UNITED STATES PATENT AND TRADEMARK OFFICE

APPLICATION NO.	FILING DATE	FIRST NAMED INVENTOR	ATTORNEY DOCKET NO.	CONFIRMATION NO.
10/773,346	02/09/2004	John C. Jaeger	21375	6802

Office Action Summary	Application No. 10/773,346	Applicant(s) JAEGER, JOHN C.	
	Examiner Anu Ramana	Art Unit 3733

DETAILED ACTION

See marked up Fig. 1 on the following page.

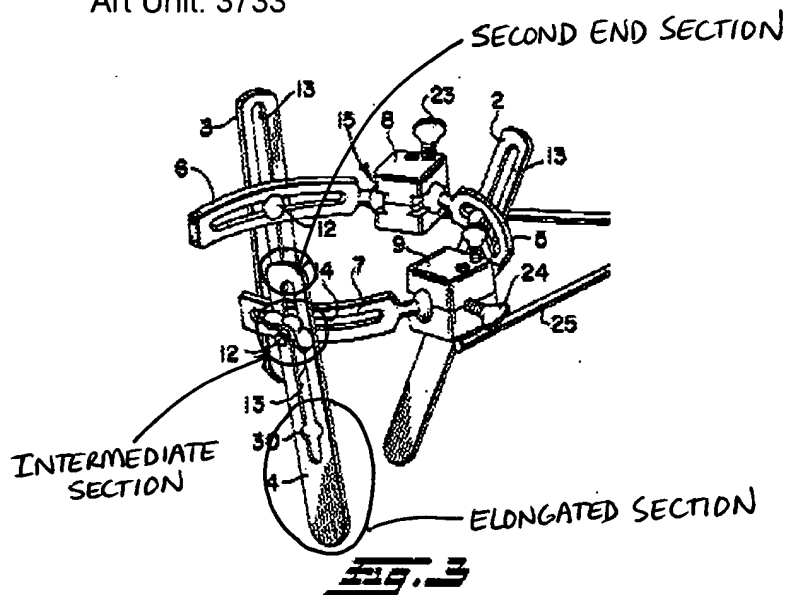
Karlin et al. disclose a retractor including: a support frame; at least three blades (2, 3, 4); and means (12) mounted on the frame and engageable by a section of each blade (Fig. 1, col. 2, lines 55-72, cols. 3-4 and col. 5, lines 1-53).

Regarding claim 10, Karlin et al. disclose a plurality of blocks 8 and 9, each of which interact with a respective end section of a respective blade by means of members 5, 6 and 7.
